UNITED STATES PATENT AND TRADEMARK OFFICE

APPLICATION NO.	FILING DATE	FIRST NAMED INVENTOR	ATTORNEY DOCKET NO.	CONFIRMATION NO.
10/675,465	09/30/2003	Sergei Kolomeitsev	VAL 169P2	5545
34232	7590	04/18/2006	EXAMINER	
MATTHEW R. JENKINS, ESQ. 2310 FAR HILLS BUILDING DAYTON, OH 45419			NGUYEN, HANH N	
			ART UNIT	PAPER NUMBER
			2834

Office Action Summary

DETAILED ACTION

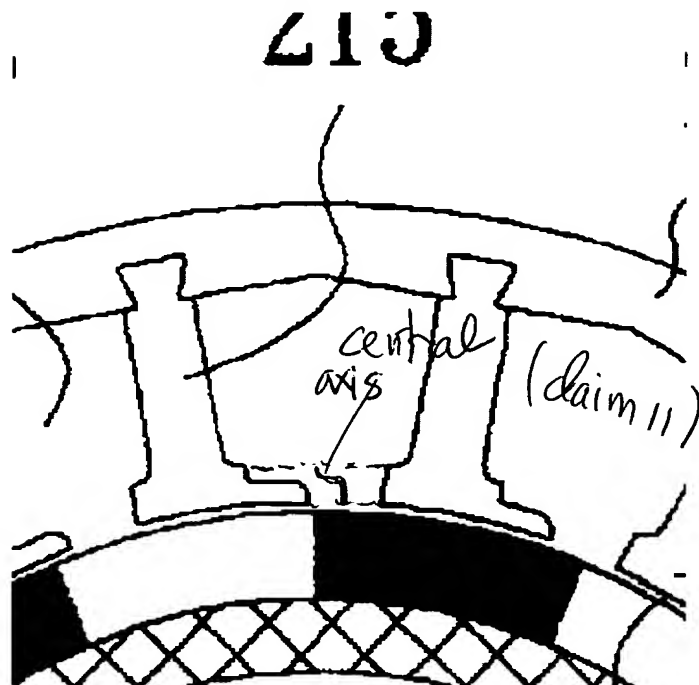
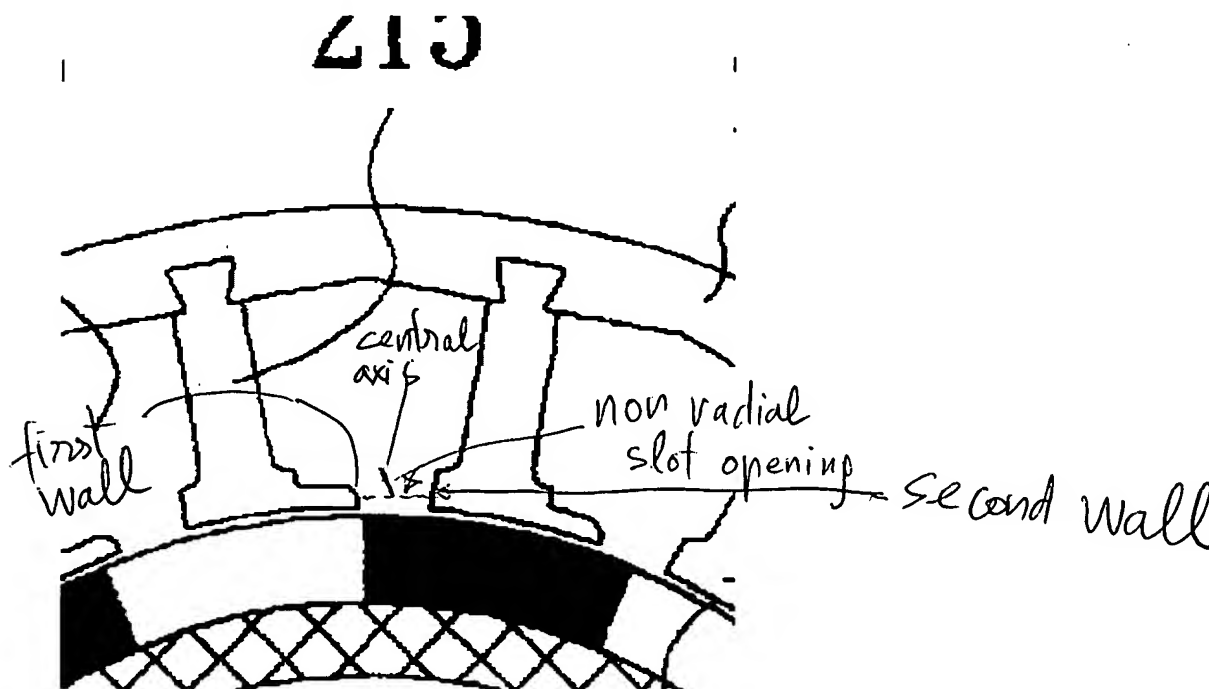
Regarding claim 2, Hsu discloses an electric motor, comprising: a pair of stator teeth (215 in Fig. 2A), having a stator slot (216) therebetween, the stator slot having slot opening which faces a rotor in the motor, and means for increasing magnetic flux passing through the slot opening (the portion end of the tooth holder which is reserved to collect the magnetic flux passing through the slot opening), wherein the means comprises a body located radially outward of the slot opening (please see markups).

Regarding claim 5, Hsu also discloses an electric motor comprising: a pair of stator teeth (215 in Fig. 2A), having a stator slot (216) therebetween, the stator slot having a radial slot opening, and a body (the portion end of the tooth holder which is reserved) located radially outward of the slot opening, which increases magnetic flux passing through the slot opening (the portion end of the tooth holder which is reserved to collect the magnetic flux passing through the slot opening).

Regarding claim 11, Hsu also discloses in an electric motor having a rotor, the improvements comprising: stator coils (inherent), and stator core means (the portion end of the tooth holder which is reserved) for decreasing mid-phase reluctance of the rotor (compare to the stator core without the portion end which is reserved) wherein the stator core means comprises a slot having a central axis, and said central axis is non-radial (please see markups).

Regarding claim 12, Hsu also discloses the improvement wherein said central axis has a radially inner region which crosses a radial line of the rotor, and a radially outer region which is spaced circumferentially from said radial line (please see markups).

Regarding claim 17, Hsu also discloses an electric motor, comprising: a rotor (31 in Fig. 2A); an array of stator teeth (215) surrounding the rotor, each stator tooth separated from its neighbor by a non-radial slot opening, which slot opening has: one wall formed by a facet of one tooth; and another wall formed by a surface of an adjacent tooth (please see markups).

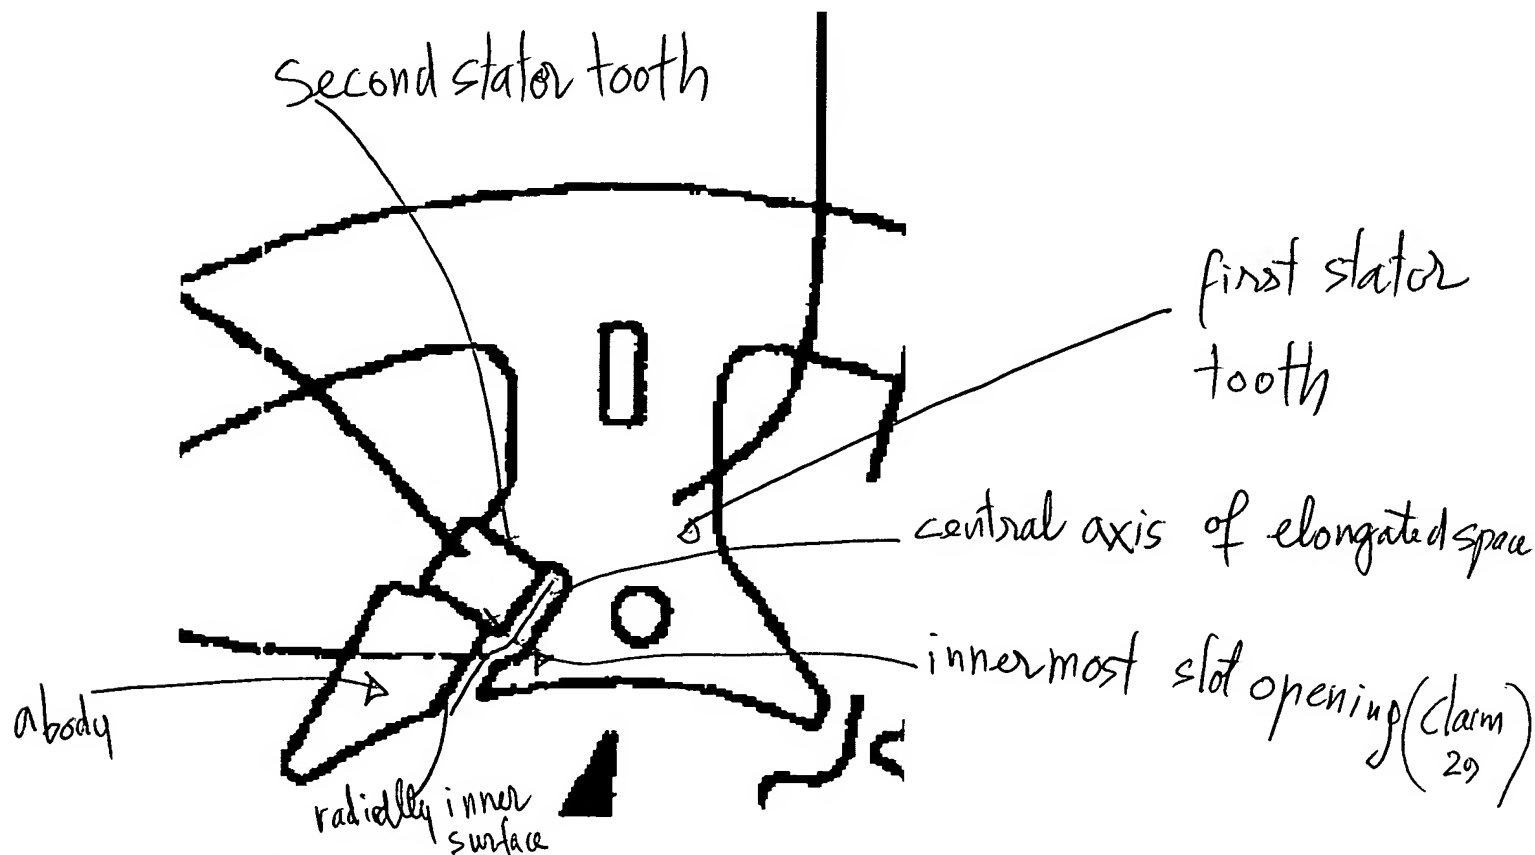
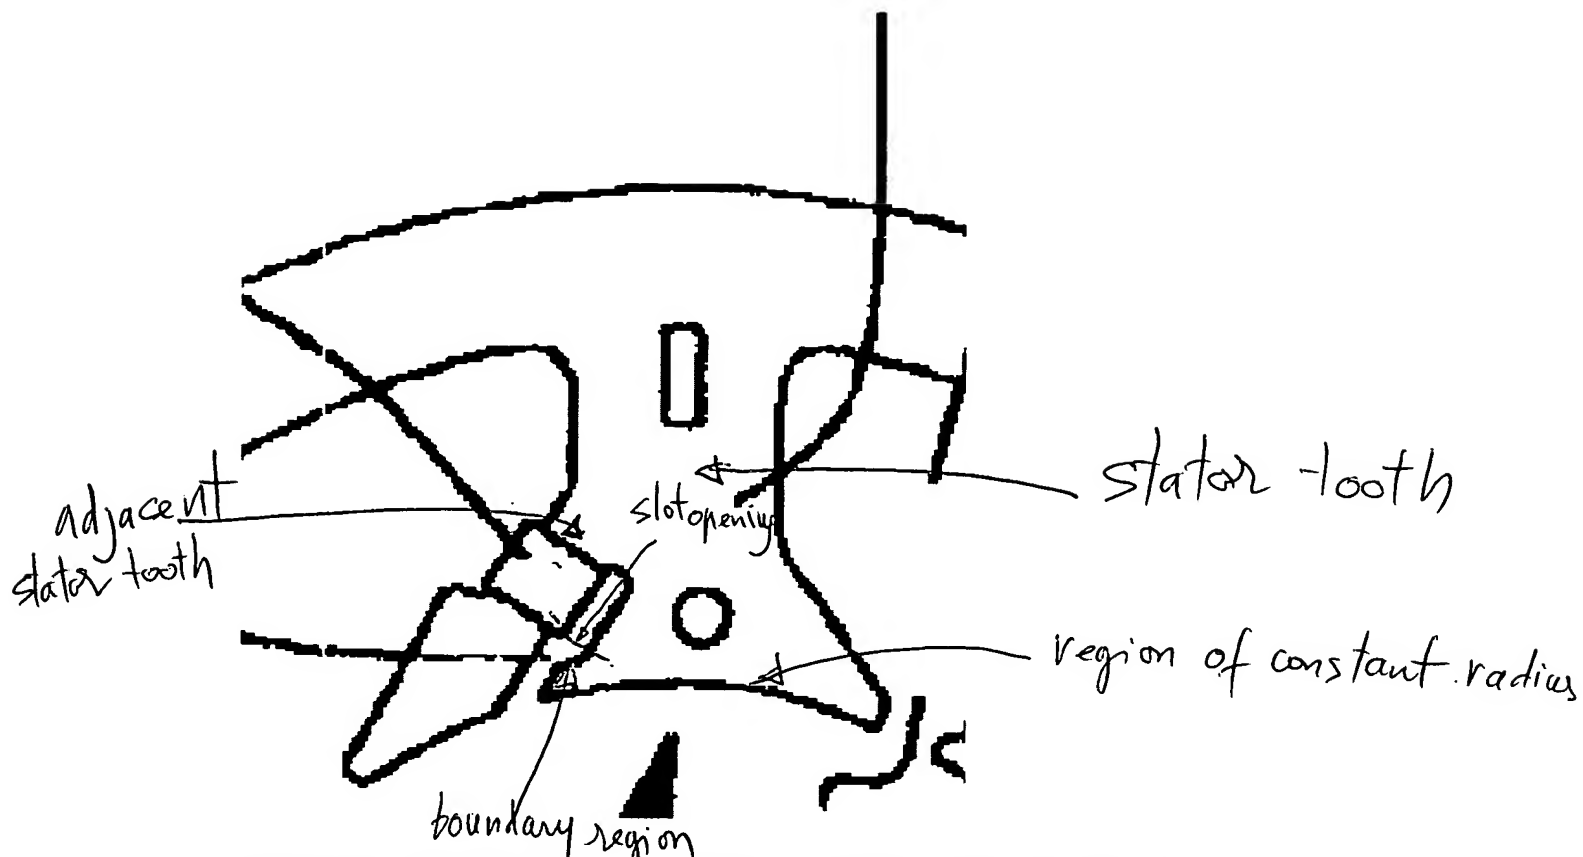
Regarding claim 27, Nutter discloses an electric motor, comprising: a first stator tooth (12 in Fig. 1); a second stator tooth; an elongated space separating the first and

second stator teeth and having a radially innermost slot opening and a central axis which is non-radial; a body (please see markups) which is magnetically continuous with the first stator tooth, and has a radially inner surface which is radially outside said innermost slot opening.

Regarding claim 28, Nutter discloses an electric motor, comprising: a rotor, a stator tooth (12 in Fig. 1) having a radially inner face which includes a first region of constant radius (the region shown by arrow 11), and a circumferential boundary region (the inside region of a body on the left hand side of tooth 12) to a slot opening that is not parallel to a radial line of said rotor, wherein the slot opening separates the stator tooth from an adjacent stator tooth.

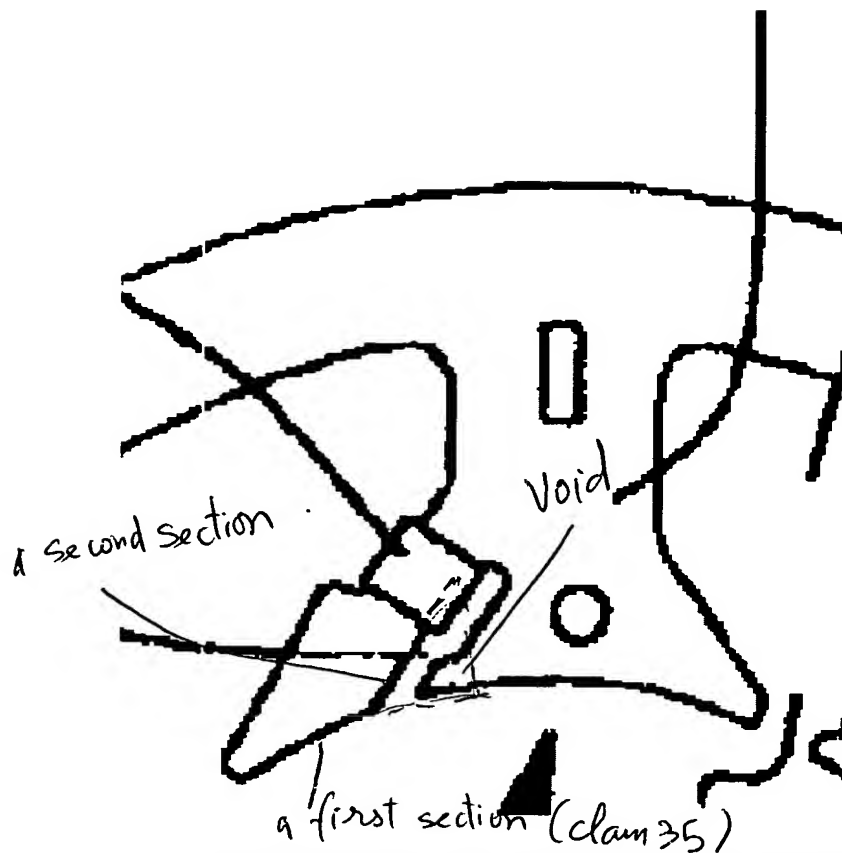
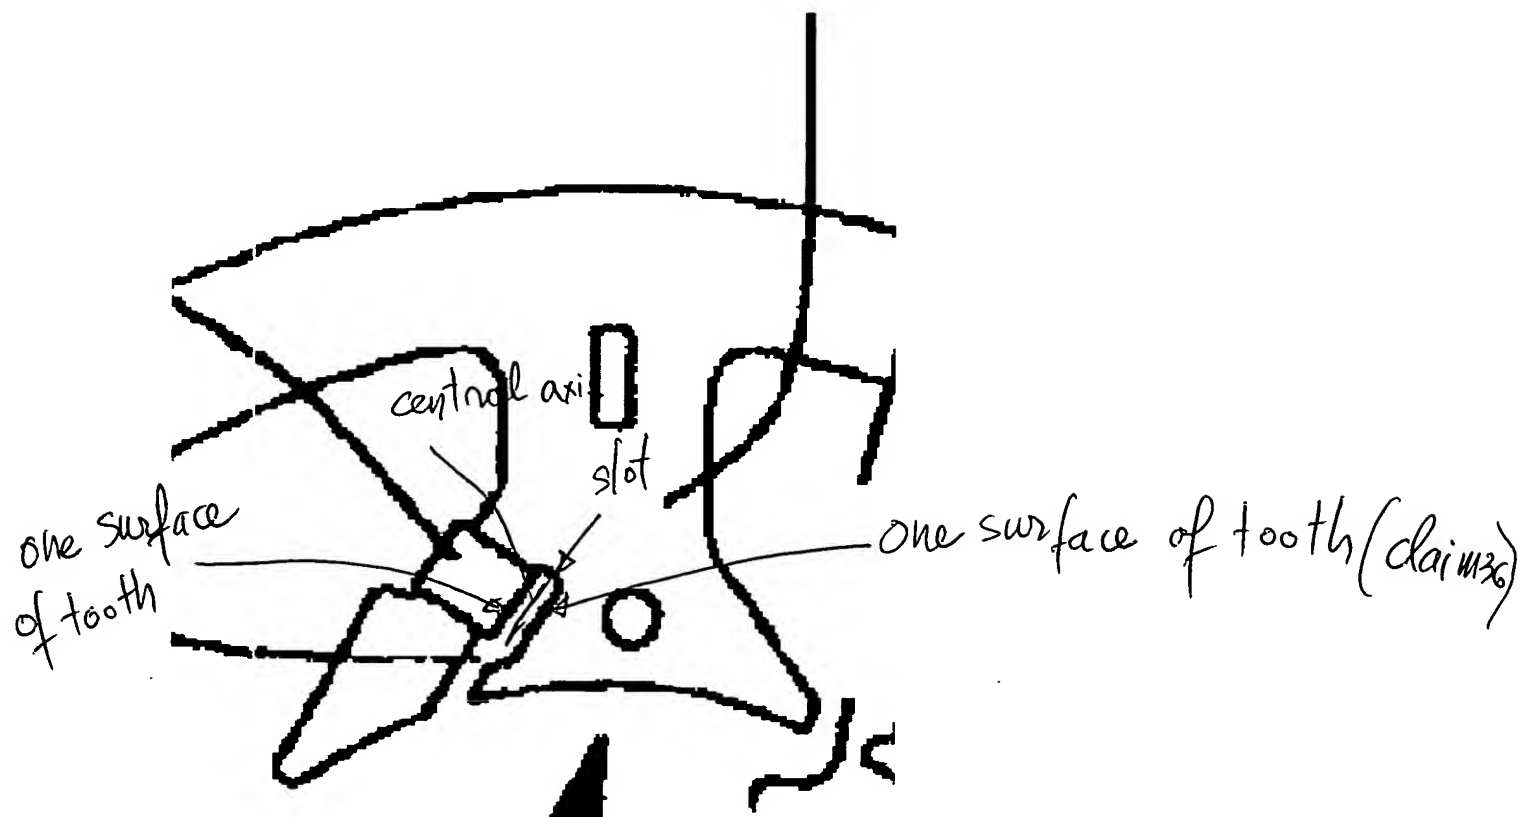
Regarding claim 35, Nutter discloses an electric motor comprising: a) a rotor having a generally circumferential outer surface; b) a first stator tooth, having a radially inner surface which includes i) a first section which is generally parallel with the outer surface, and ii) a second section which A) is non-parallel with said outer surface and B) cooperates with said outer surface to form a void; c) a second stator tooth having a section which extends into the void (please see markups).
